Architectural Design Report - Response to Submission

# UNSW Health Translation Hub

This report has been prepared on behalf of UNSW as an addendum to SSD 10822510 for the Health Translation Hub building.

The report has been compiled to respond to the design-related submissions received by the Department of Planning and Environment and Randwick City Council during the public exhibition of the UNSW HTH.

## Item 34. Roof Top Terrace

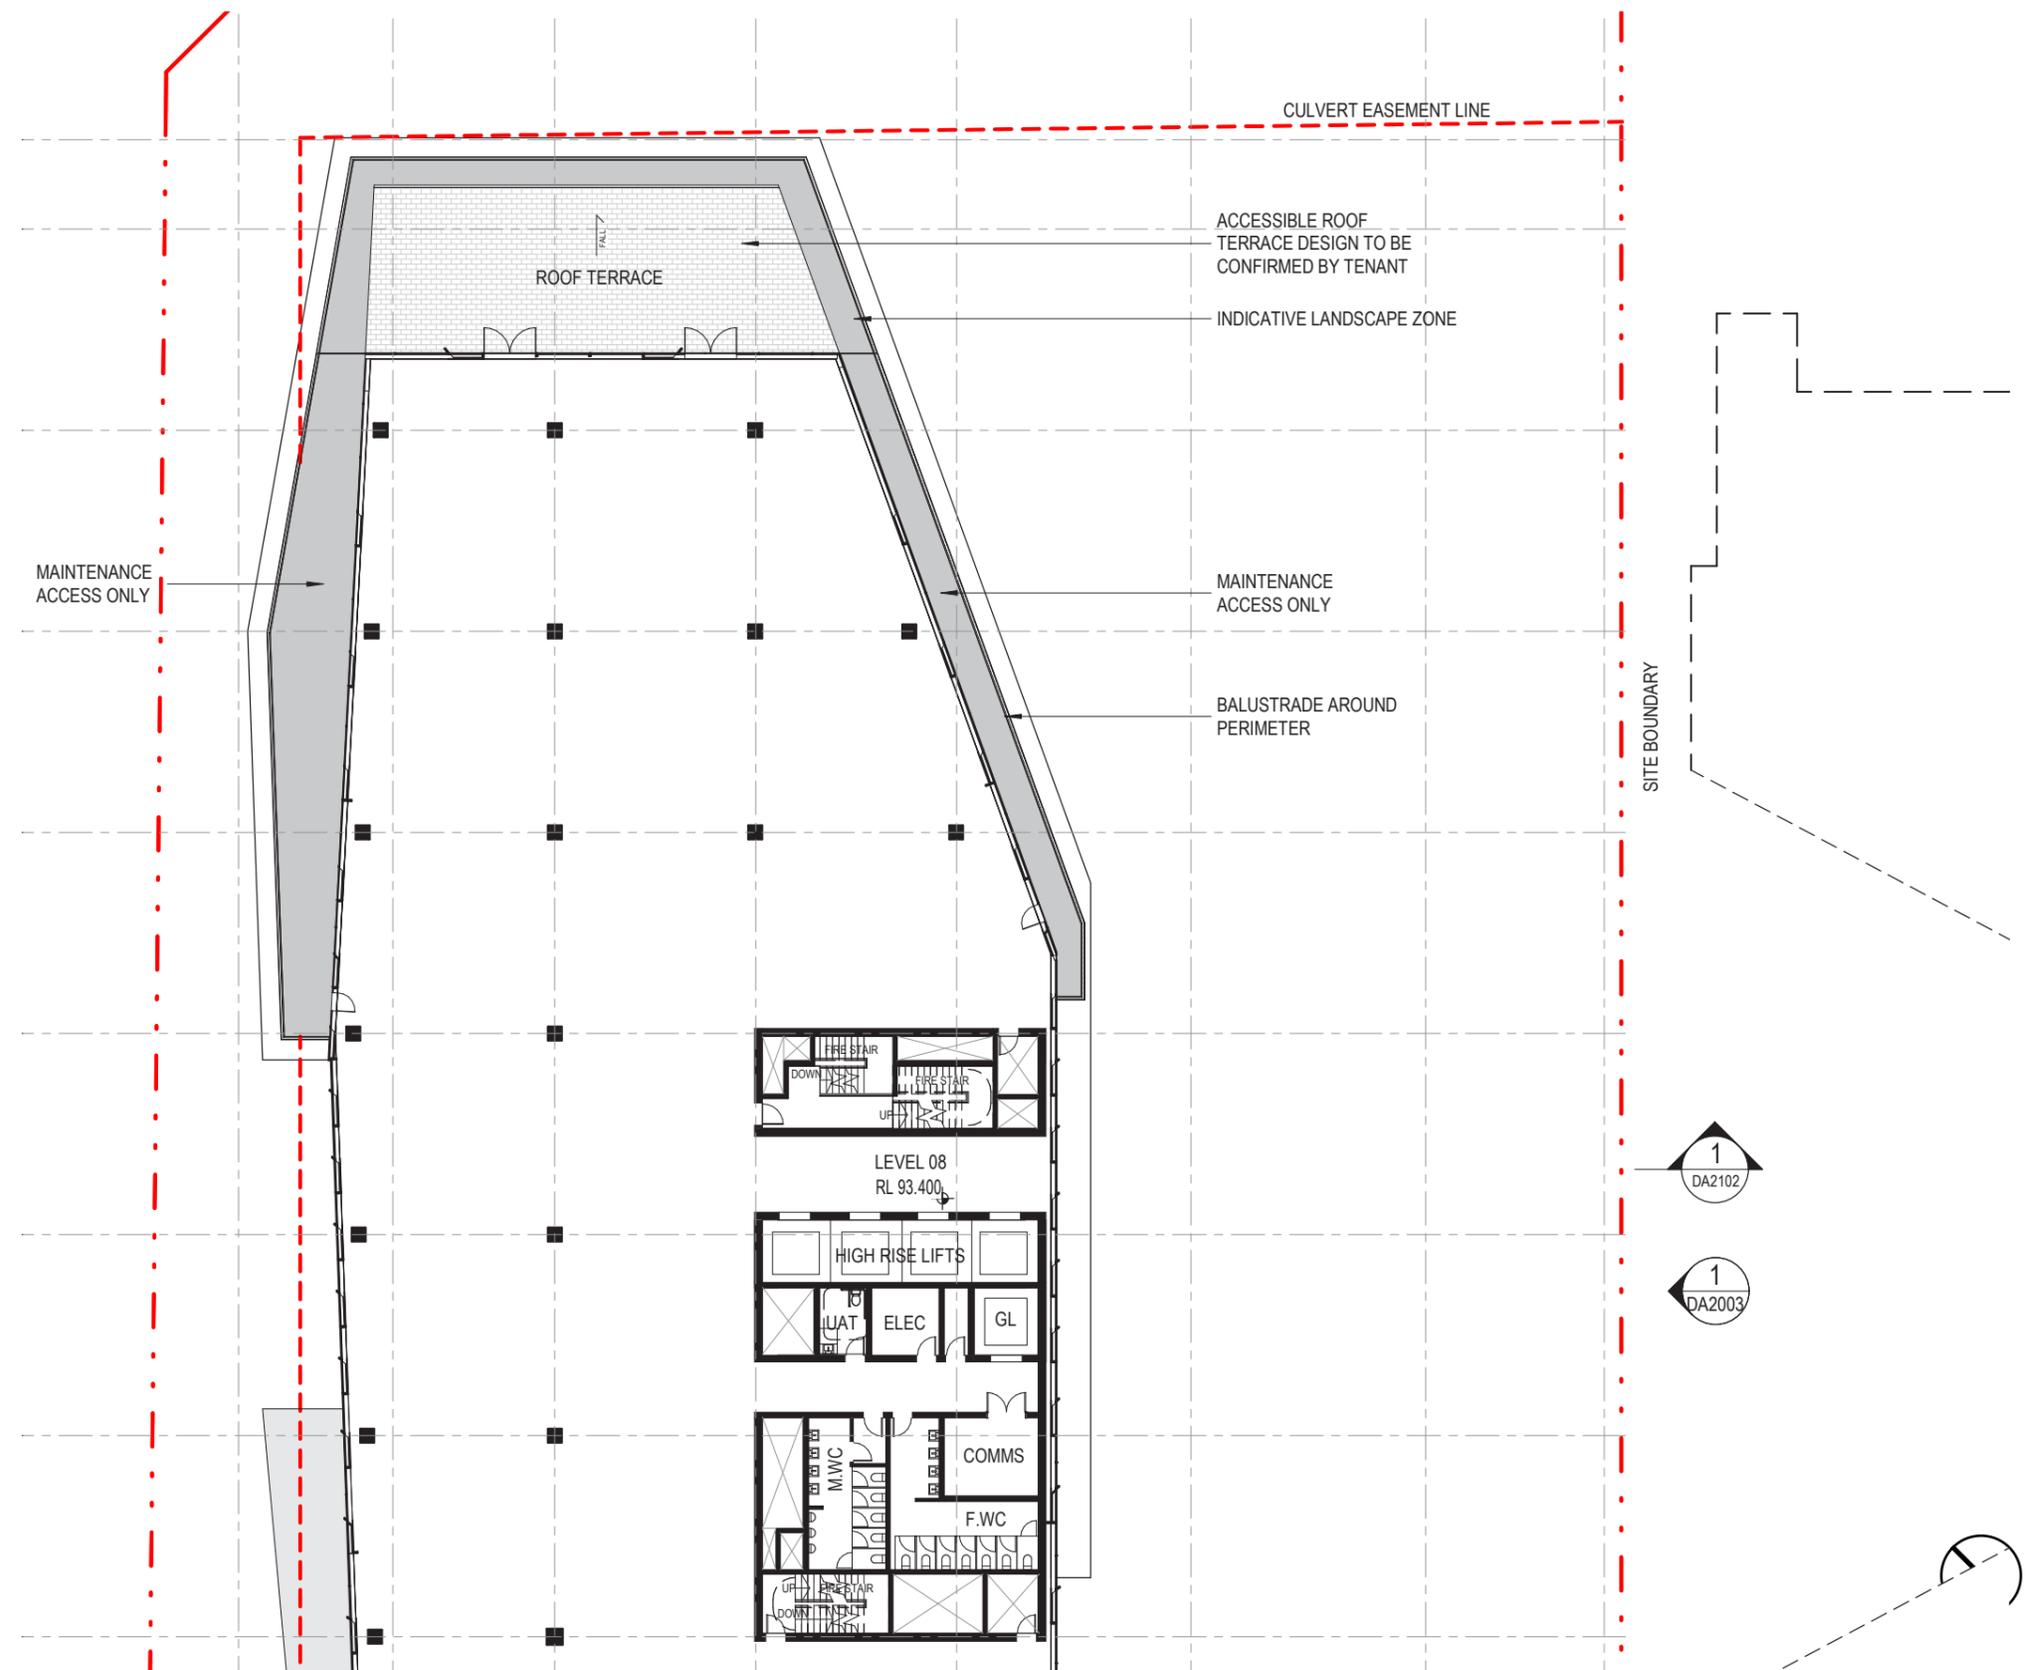
Further consideration should be given to the provision of outdoor roof terraces to provide amenity for occupants as well as opportunities for outdoor learning or breakout spaces. GANSW have advised that “no access to outdoor learning or breakout spaces is considered a poor outcome”.

Further landscape detail is required for the proposed roof level and upper level terraces. The podium roof areas should be utilised to provide outdoor landscaped terrace areas for workers and visitors where possible.

The design team supports the recommendation to make the roof top terrace spaces accessible and include additional landscaping. The northern roof top that is accessible from level 8 has been selected as the most appropriate location due to its northern aspect, expansive views and advantageous weather/wind protection.

This has been reflected in the revised level 8 plan, that includes a mixture of accessible outdoor amenity to the north and maintenance zones to the east and west.

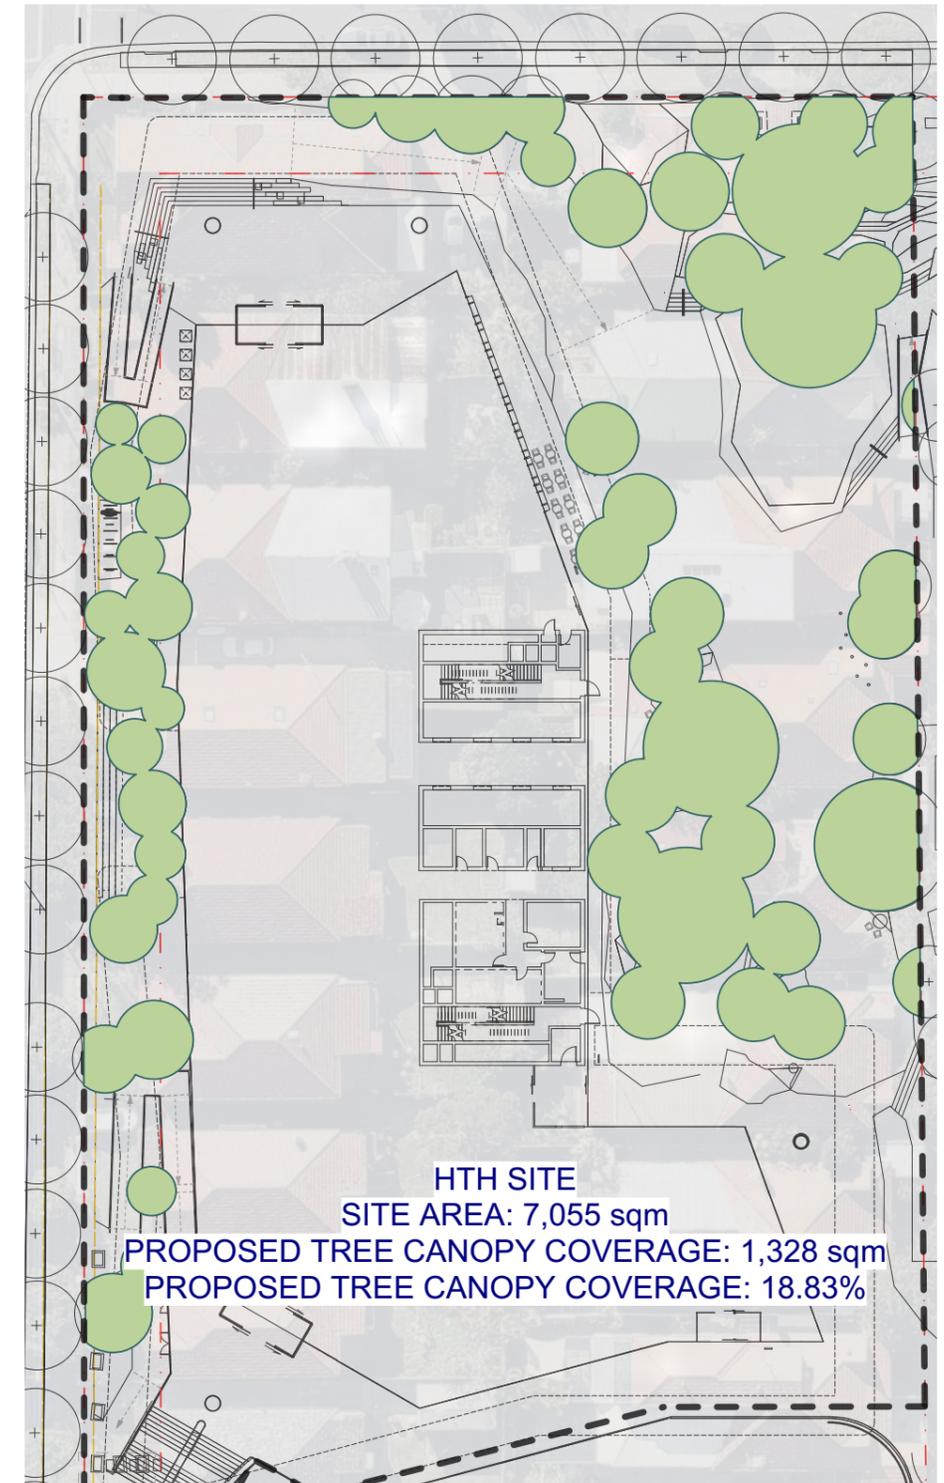
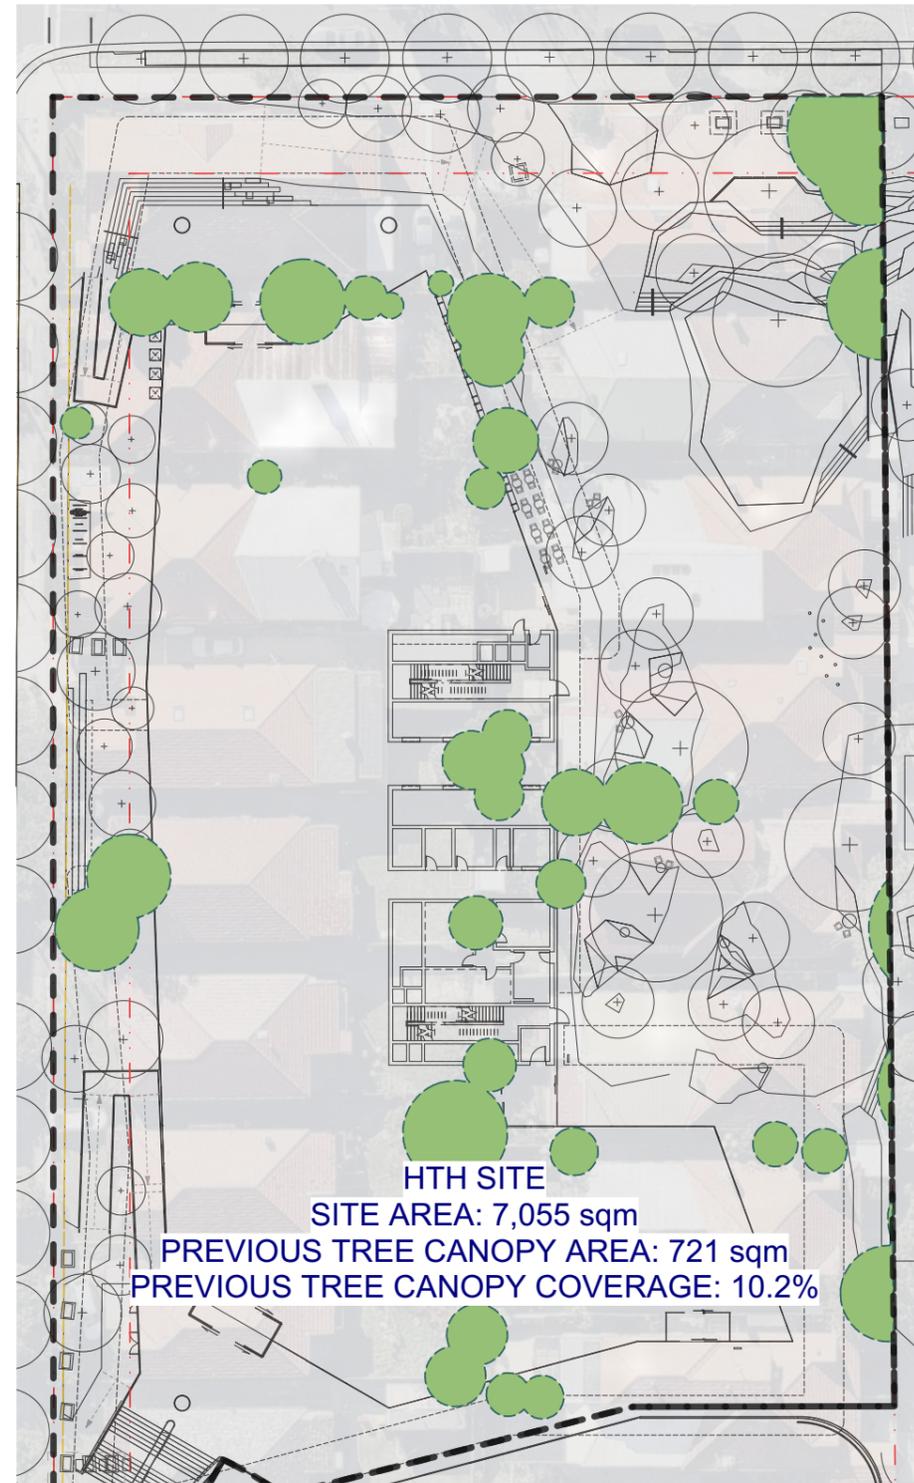
“Consideration should be given to improving tree canopy cover, noting the proposed 14 per cent coverage falls short of minimum 25 per cent recommended within the NSW Government Architect’s Draft Greener Places Design Guide. Any comparisons against the ‘existing’ canopy coverage to justify the proposed canopy cover should be based on an assessment of the canopy cover of the previous residential use of the site, prior to clearing of the site.”

The revised tree canopy of 18.83% provides the maximum possible coverage capacity within the site whilst also balancing the key precinct principle of maintaining clear, open and intuitive wayfinding.

The site is currently devoid of vegetation, however the previous residential use of the site had a tree canopy coverage of 10.2%. We have located additional trees where soil depth is appropriate, particularly within the northern landscape embankment and the plaza planters. Tree planting within the stormwater culvert has been restricted to areas which allow for substantial mounding resulting in a greater soil volume.

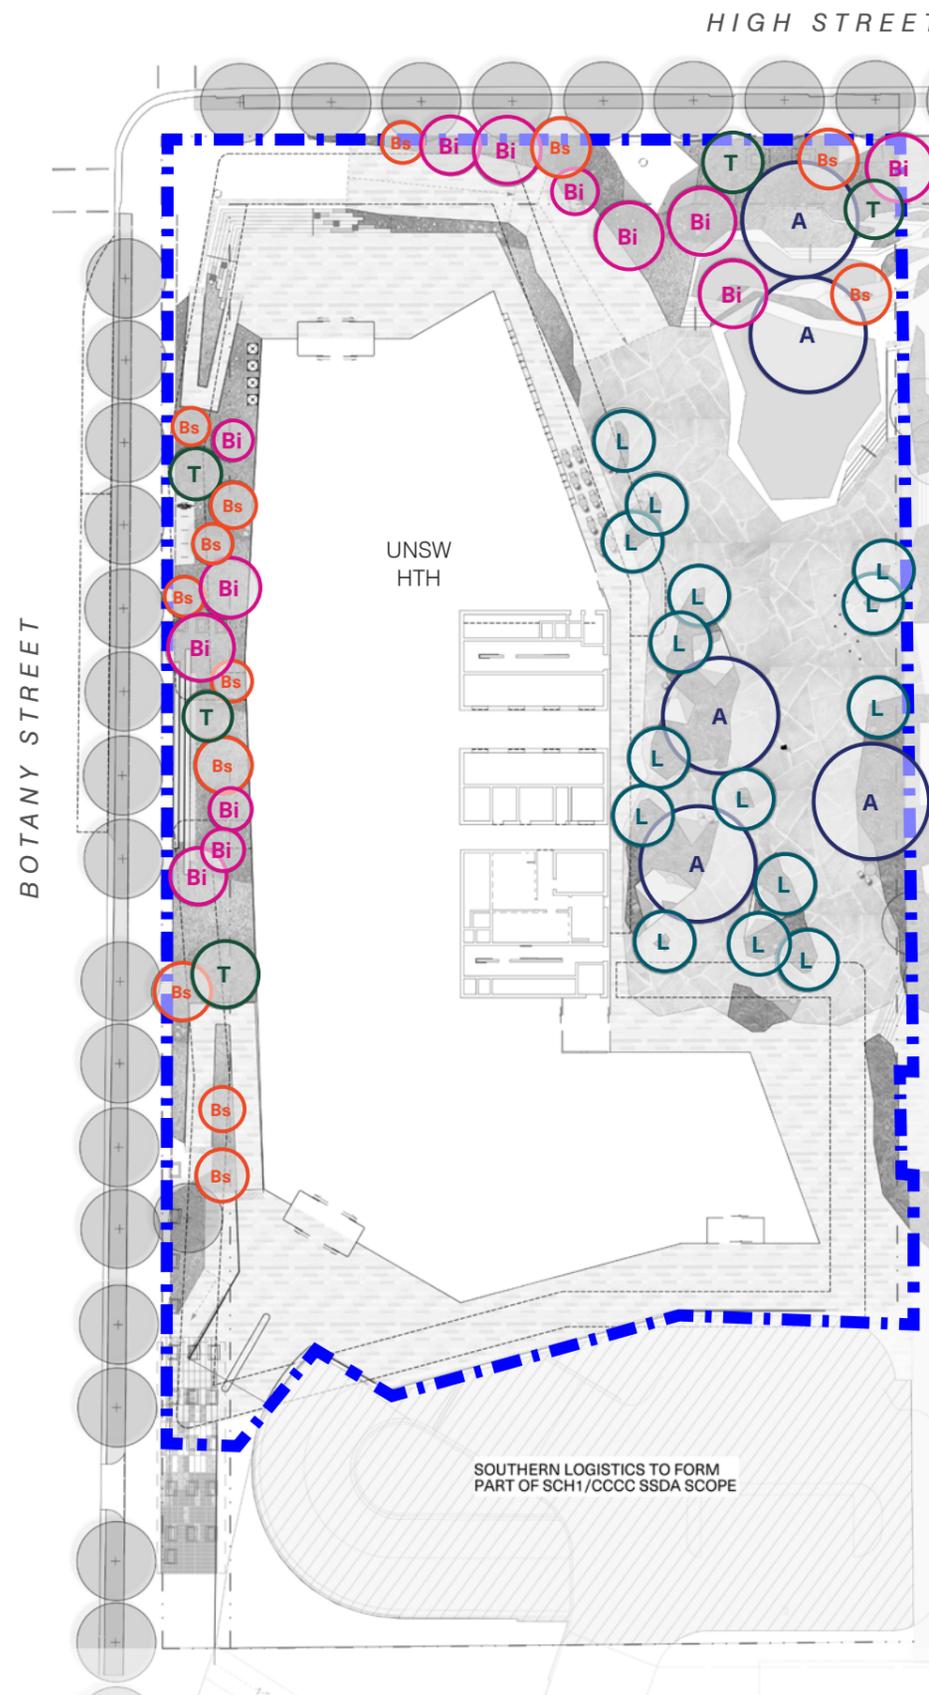
- Clarify the provision and specifications of any permeable paving.

There are very few permeable pavers that are appropriate for a high traffic, urban plaza environment. Proprietary interlocking pavers create issues for DDA compliance and risks of trips and falls with the gaps between them, and bonded aggregate types are more appropriate around tree pits and in low traffic movement zones due to longevity of the product. Further information on the provisions and specifications of permeable paving has been provided apart of *Item 32. Landscaping.*
